Accessibility Survey

City of Downey Colombia Way - Foster Road to Lakewood Boulevard

Date of Inspection
11/30/2016

Disability Access Consultants

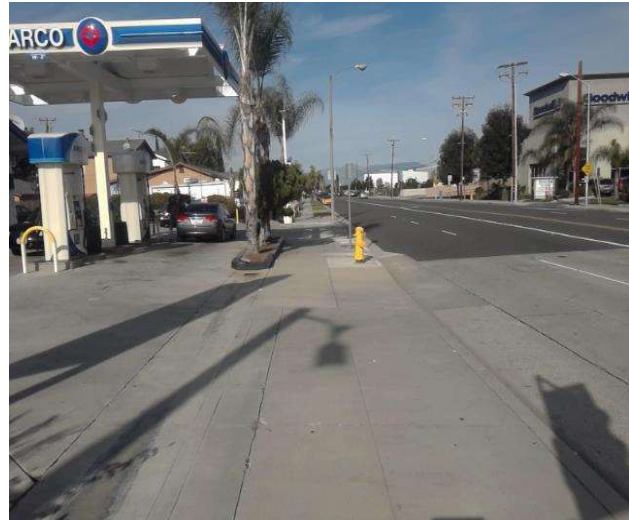
There are no detectable warnings where the pedestrian route crosses vehicular traffic.

On-Site Finding Not Found

Provide detectable warnings.

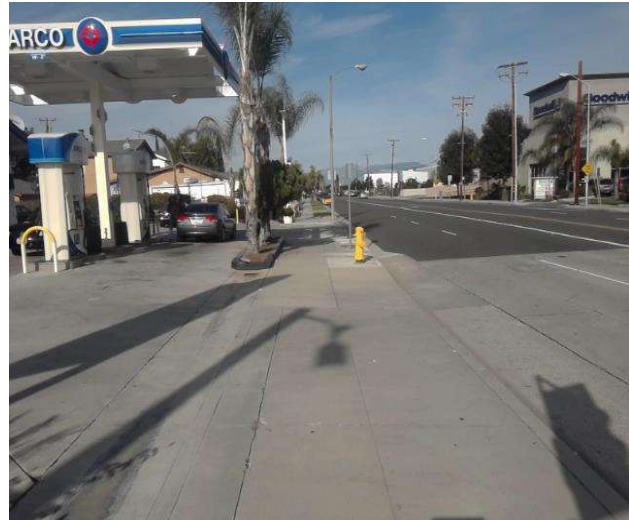
Cross slope at vehicular traffic is not compliant.

On-Site Finding 6.40 percent

Repave the surface to provide a compliant cross slope.
